INDESIT company

Model type:
MTM1721CFR

Commercial code:
F036377

51720b0 Exploded views

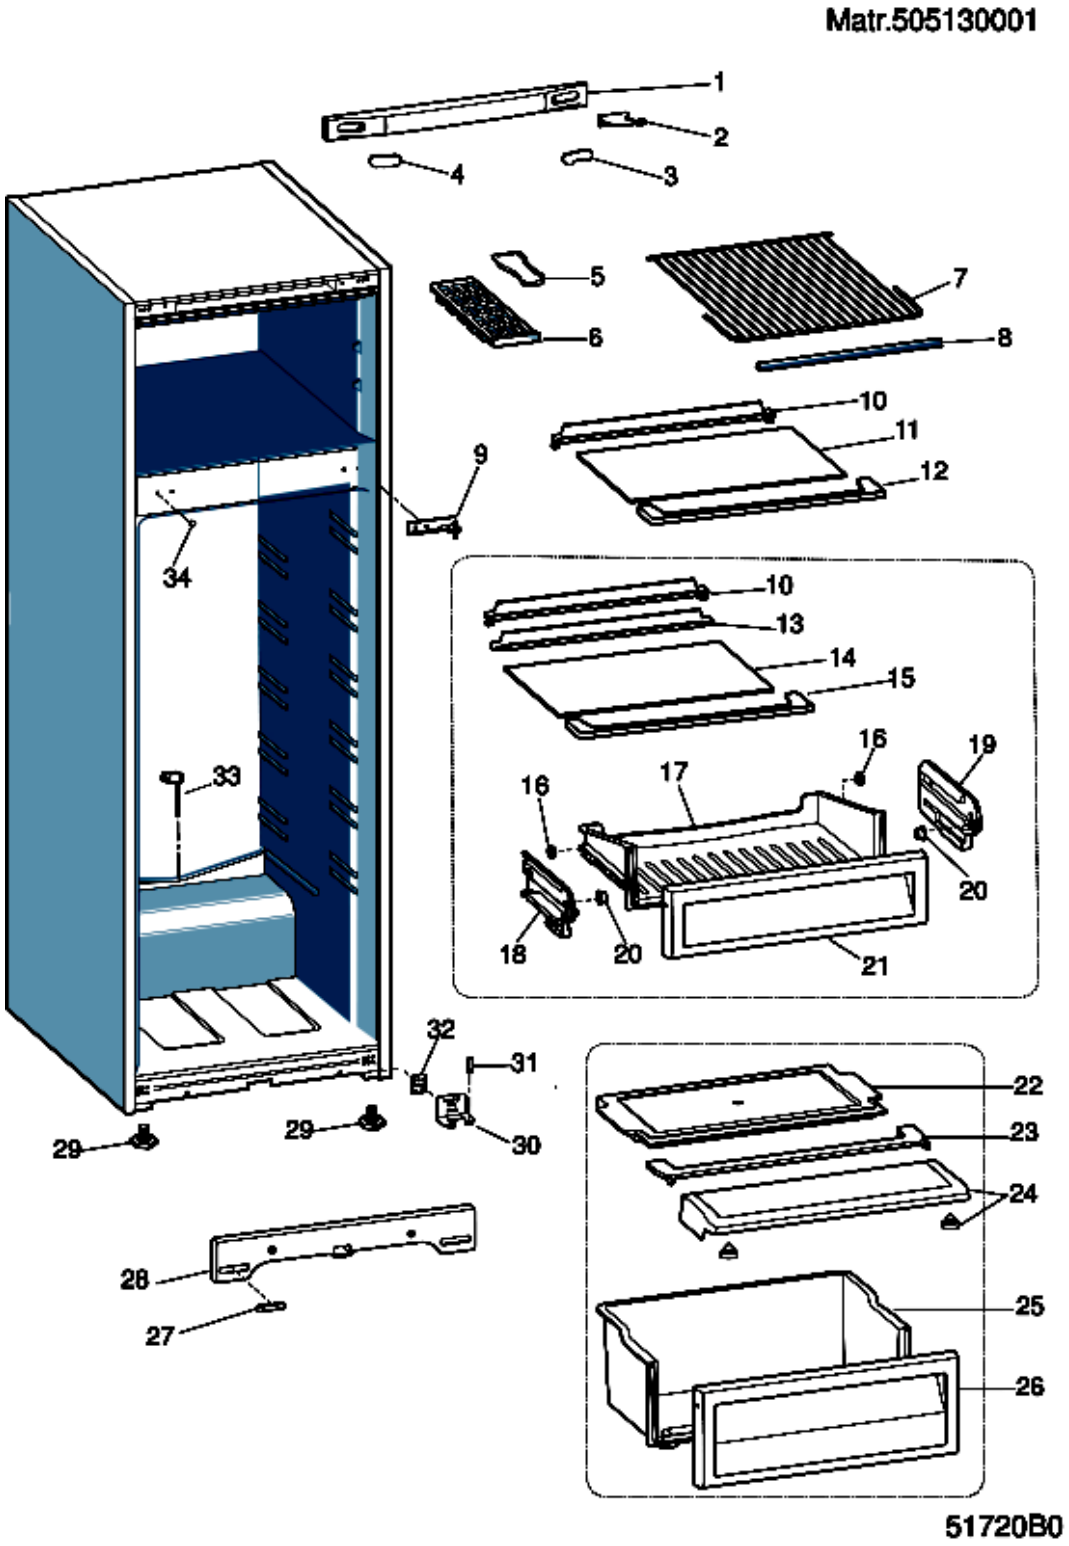
n2510j00: SUBSTITUTION LOWER HINGE PIN

In order to make better the assembly and to prevent an accidental unscrewing of lower hinge pin with consequent falling down of the door, original pin has been substituted by another one longer.

In the course of the time more than one pin has been tested, therefore the history of the substitutions is reported:

C00017658 (13.5mm) --> C00259768 (21mm) --> C00281425 (23mm)

For quality issues on interested models is managed only the last one C00281425 (23mm).

5172190 Exploded views

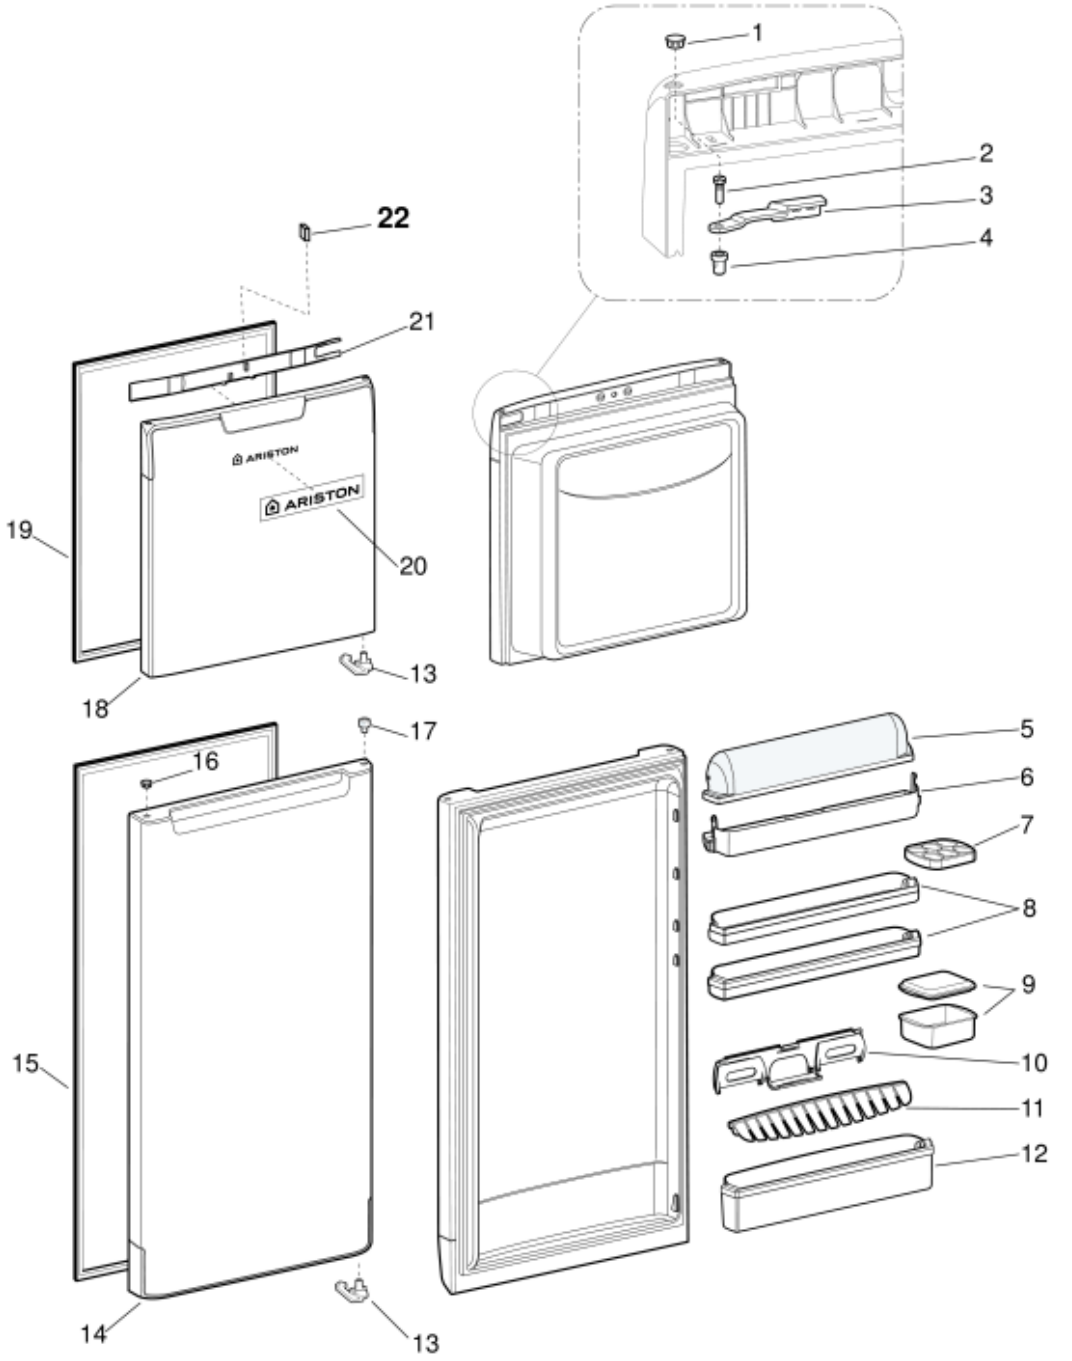
n2512f00: DOORS CHANGE

Original doors are not longer available so it will be necessary to substitute them with a new couple of equivalent doors: NEW doors have a DIFFERENT AESTHETICS. The engineer need the DOOR CONVERSION KIT C00291892 to apply them to the product.

New door codes to order are:

C00290309 FG
C00290311 FZ
